## TEXAS COMMISSION ON ENVIRONMENTAL QUALITY

Re: Edwards Aquifer, Comal County  
NAME OF PROJECT: Metamorphic Design; located at 18636 Forty-Six Parkway, Bulverde, Texas  
TYPE OF PLAN: Request for the Approval of a Contributing Zone Plan (CZP); 30 Texas Administrative Code (TAC) Chapter 213 Subchapter B Edwards Aquifer  
Edwards Aquifer Protection Program San Antonio File No. 232.01; Investigation No. 826029  
Regulated Entity No. RN105187652; Additional ID 13-07021306

**RE:** Metamorphic Design CZP (EAPP No. 232.01)  
Response to Additional Comments

Re: Metamorphic Design Contributing Zone Plan (CZP)  
Edwards Aquifer Protection Plan (EAPP) No. 232.01  
Response to Notice of Deficiency (NOD)

EXHIBIT 1

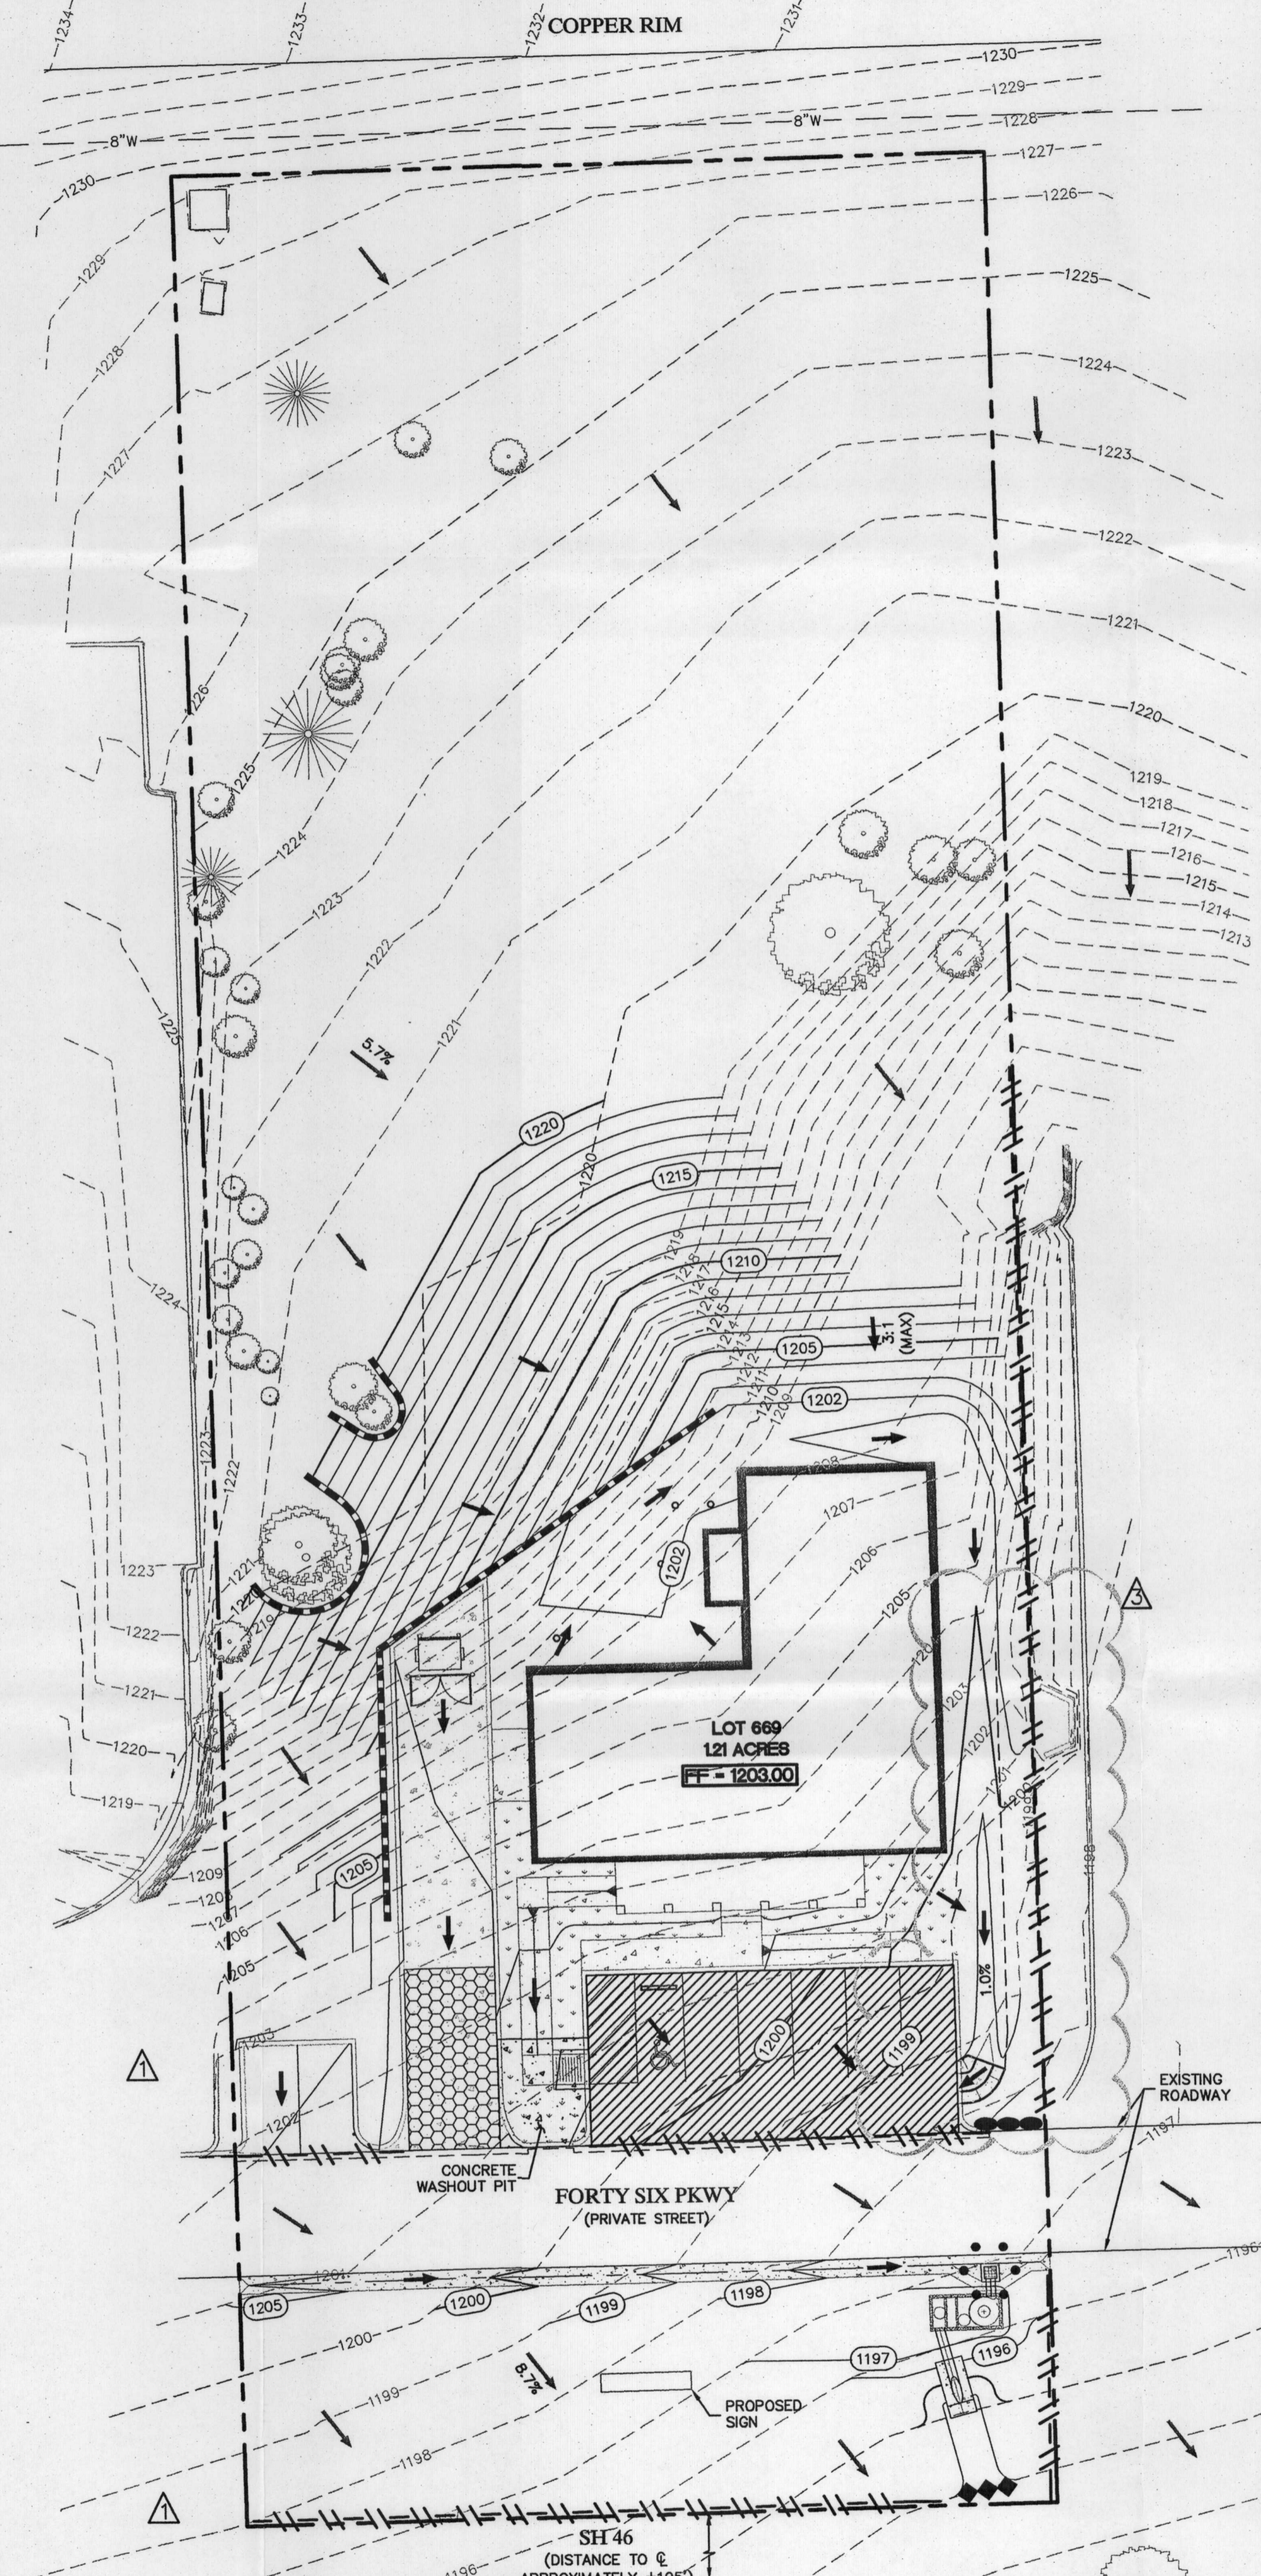
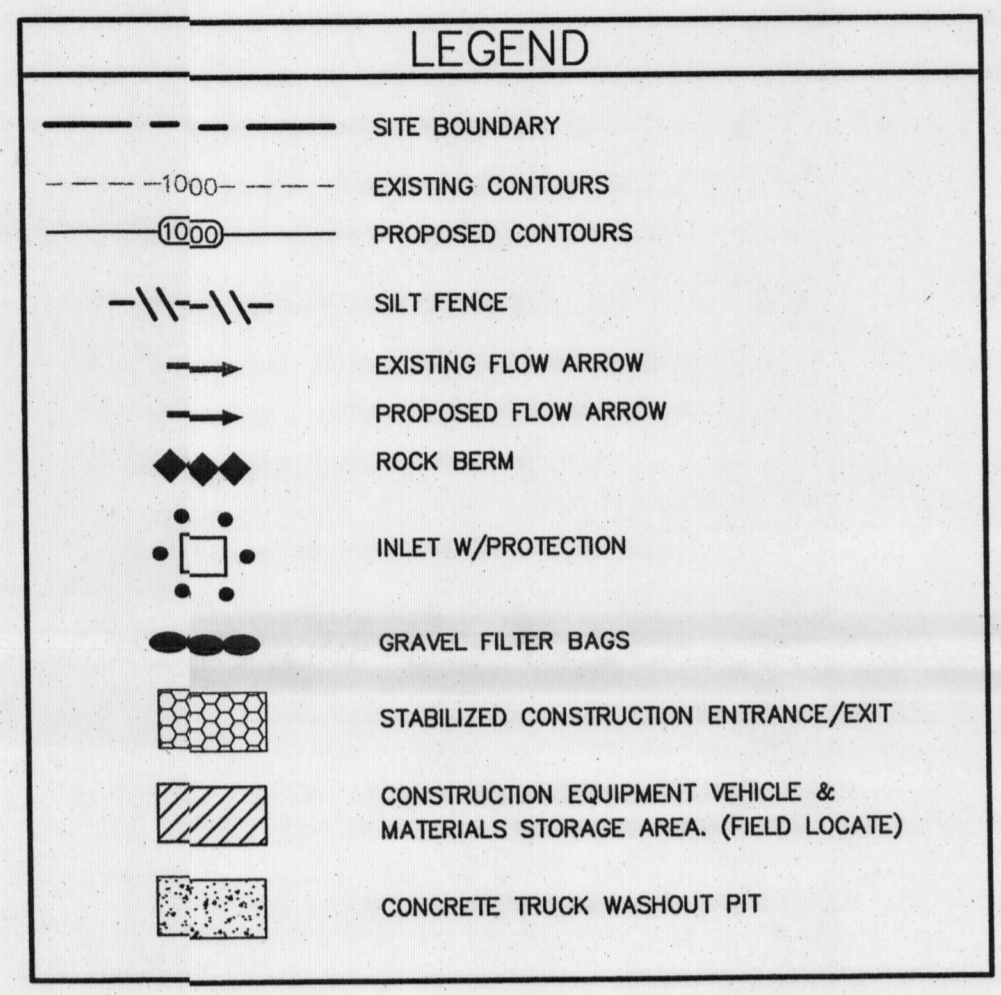
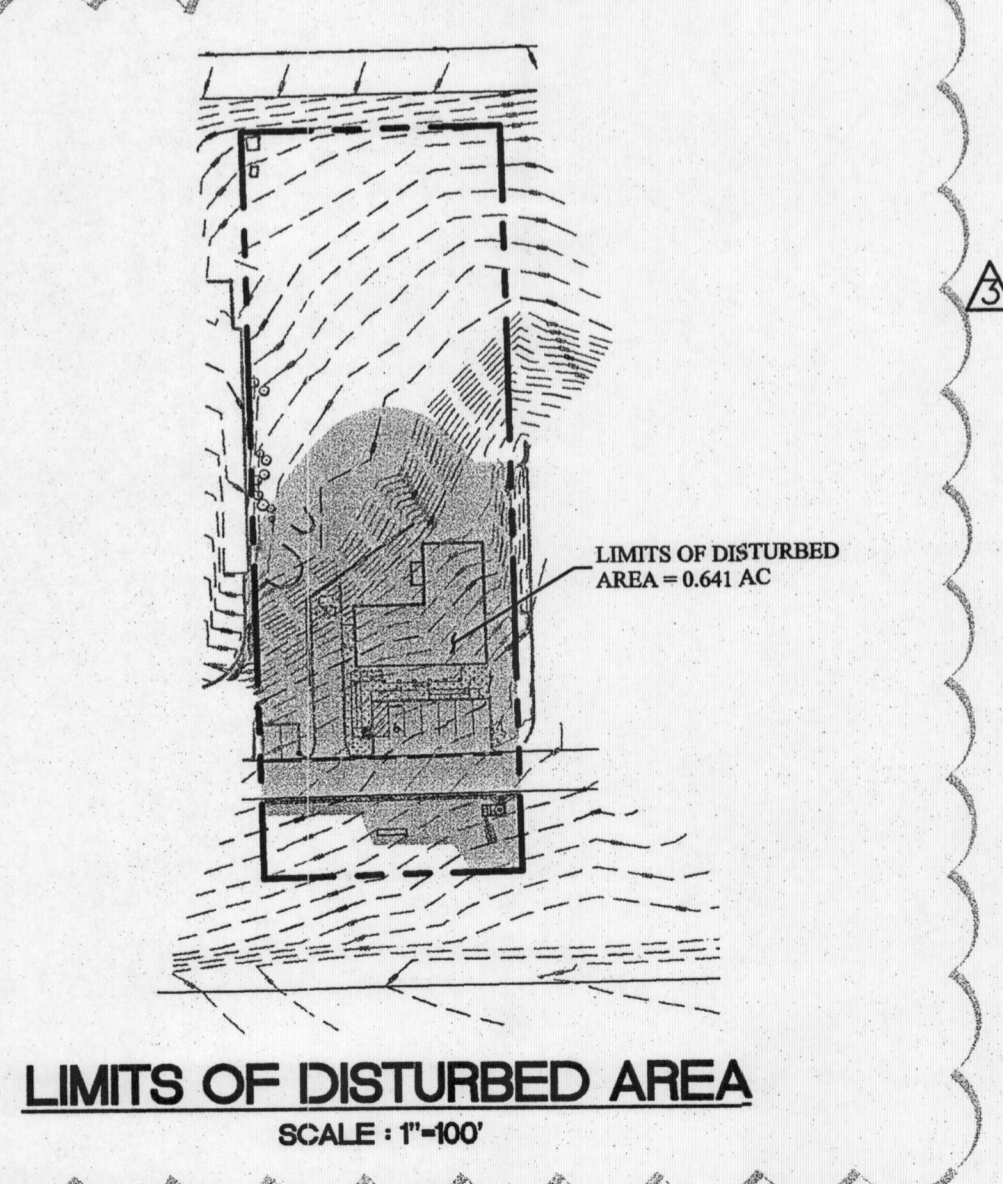
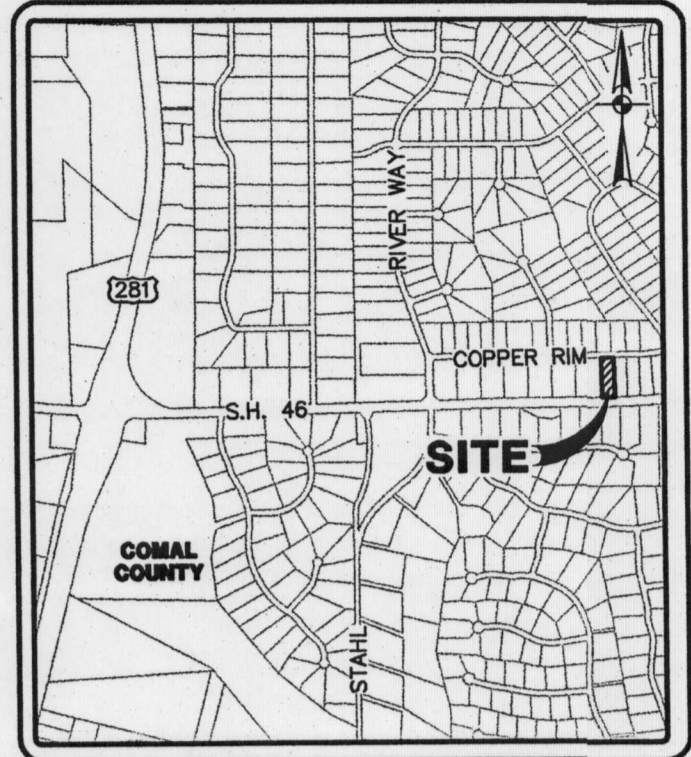
2. Exhibits 1 and 3 (the Site Plans):
  - a. On both Site Plans, at the bottom of the TCEQ CZP Construction Notes, please provide the following statement -- THESE GENERAL CONSTRUCTION NOTES MUST BE INCLUDED ON THE CONSTRUCTION PLANS PROVIDED TO THE CONTRACTOR AND ALL SUBCONTRACTORS.

- b. Specifically label on the Site Plans the areas which will be disturbed and clarify Item 35 accordingly.
  - c. On Exhibit 3, provide revisions to the data tables and plan view for the changes in treatment calculation assumptions and results and the proposed BMT.

- d. Annotate where the outfall from the BMP will immediately go.
3. Exhibit 4:
  - a. Per Item 53, as applicable, show where the energy dissipators will be located.

2. Exhibits 1 and 3 (the Site Plans):

- a. On both Site Plans, at the bottom of the TCEQ CZP Construction Notes, please provide the following statement – THESE GENERAL CONSTRUCTION NOTES MUST BE INCLUDED ON THE CONSTRUCTION PLANS PROVIDED TO THE CONTRACTOR AND ALL SUBCONTRACTORS.
- b. Specifically label on the Site Plans the areas which will be disturbed and clarify Item 35 accordingly.
- c. On Exhibit 3, provide revisions to the data tables and plan view for the changes in treatment calculation assumptions and results and the proposed BMP.
- d. Annotate where the outfall from the BMP will immediately go.

*Response:*

- a. *This statement appears to be direction to the user and not an actual construction note; therefore, it is not included.*
- b. *The limits of disturbance are approximately 0.641 acres, from the southern property line to the limits of grading shown on the plans. This boundary has been added to Exhibit 1.*
- c. *Please see the response to "2.a" of the TCEQ-10257 comments below.*
- d. *The outfall from the Vortechs unit is shown on Exhibit 1 and 3. Flow is discharged via pipe to a grassed area at the southern property line. No revision is necessary. Flow will ultimately flow to a ditch running parallel to the highway diverting upgradient flow to an existing crossing underneath SH46.*

- c. *Please see the response to "2.a" of the TCEQ-10257 comments below.*
  - d. *The limits of disturbance are approximately 0.641 acres, from the southern property line to the limits of grading shown on the plans. This boundary has been added to Exhibit 1 and the figure revised.*
